Agenda Item **No. 5(h)**
Meeting of July 16, 2019

SUBJECT: Approving amendments to the Mission Bay South Signage Master Plan to: increase the limits of residential signage; decrease the clearance for fin signs; and to allow directional signage standards for residential and mixed use retail uses; an implementing action under the Mission Bay Subsequent Environmental Impact Report, a Program EIR; and adopting environmental findings pursuant to the California Environmental Quality Act; Mission Bay South Redevelopment Project Area

Attachment: Proposed 3E (Edwin M. Lee a Veterans and Family Community) Signage

3 SECTION AT MAIN ENTRANCE
SCALE: 3/8" = 1'-0"

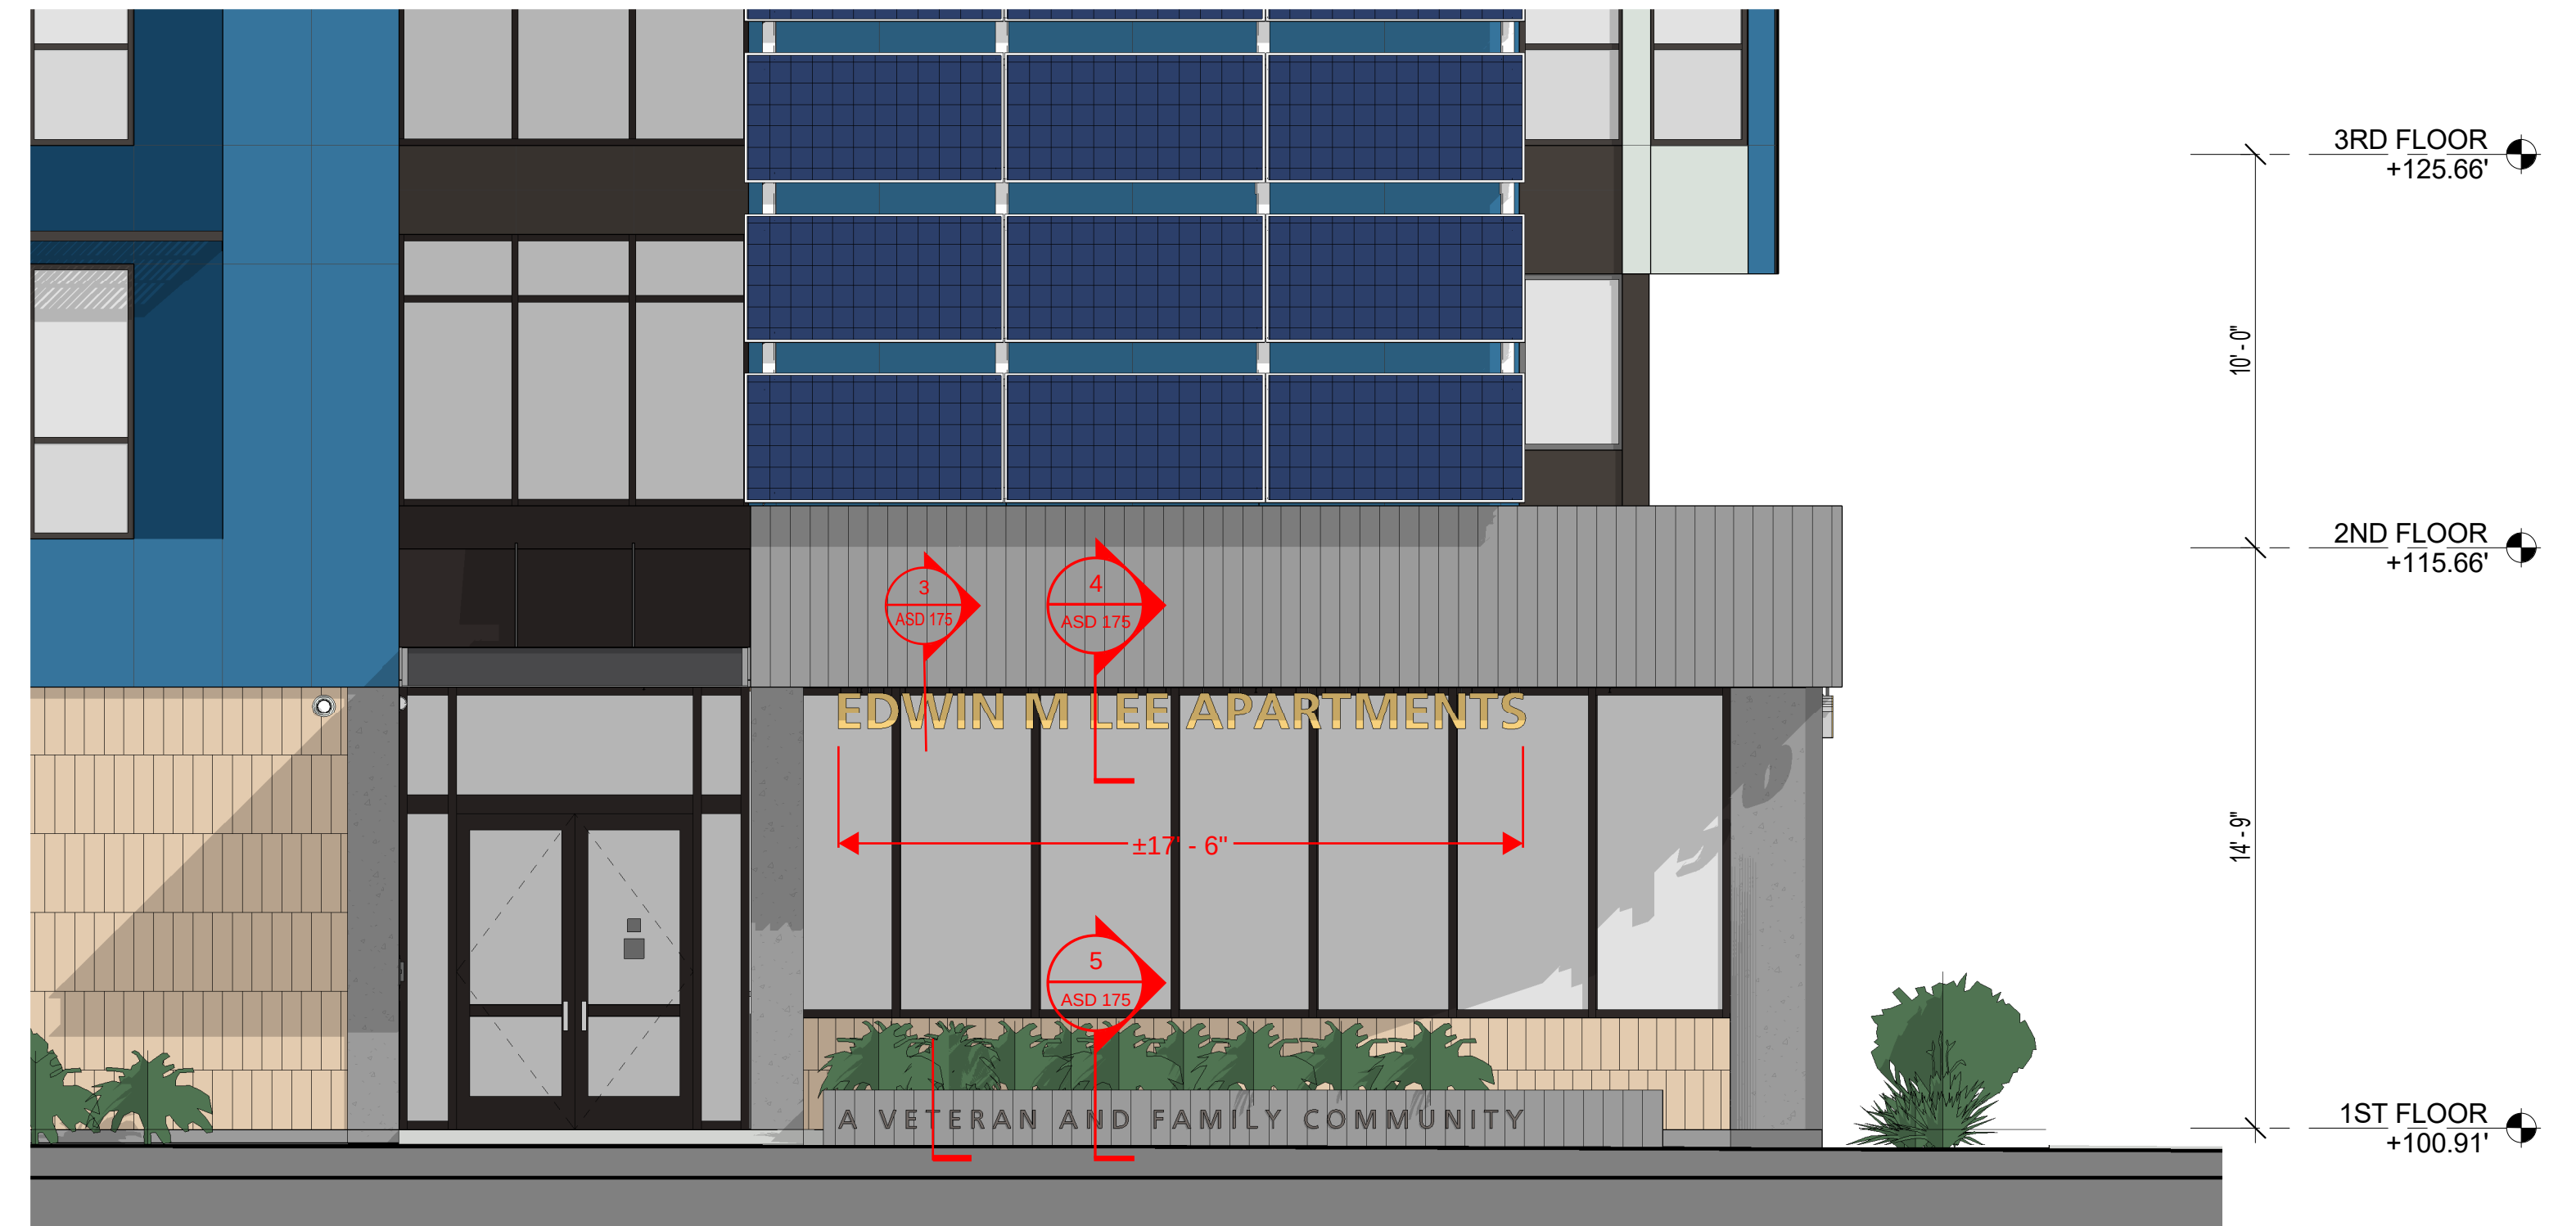
After reviewing the proposed signage for the affordable housing nearing completion on Block 3E, OCII staff determined that some of the standards are too limiting on the practical signage needs of some projects. Therefore, OCII is requesting approval of the following amendments to the Signage Master Plan: to increase the limit of residential signage on each parcel to a maximum of fifty square feet of sign area with no single street frontage exceeding thirty square feet and no individual sign to exceed fifteen square feet; to decrease the lower edge of commercial / industrial, hotel and mixed use retail fin signs from twelve feet to ten feet above the sidewalk; and to establish directional standards for residential and mixed use retail uses ("Master Signage Plan Amendments"). The proposed

The current residential standards allow for identification signage at a maximum square footage to be placed on each parcel street frontage with a slightly larger amount on 3rd and 4th streets including nameplates, wall signs and awning signs. Many projects have multiple or longer building names associated with a benefactor, a member of the community being honored, or property development firm. The current sign limits are too small and do not allow longer building names to be effectively communicated to visitors and pedestrians or vehicles passing by. Mission Bay South Block 3E, an affordable housing project, is proposed to be named after the late Mayor Lee (see attached); the current standard does not allow the building name, Edwin M. Lee a Veterans and Family Community, to be at implemented at a legible scale. The current and proposed amendment read as follows:

- The maximum signage program sign area allowed per parcel shall be 50 square feet with no single street frontage exceeding 30 square feet. Each individual sign shall not exceed 15 square feet.
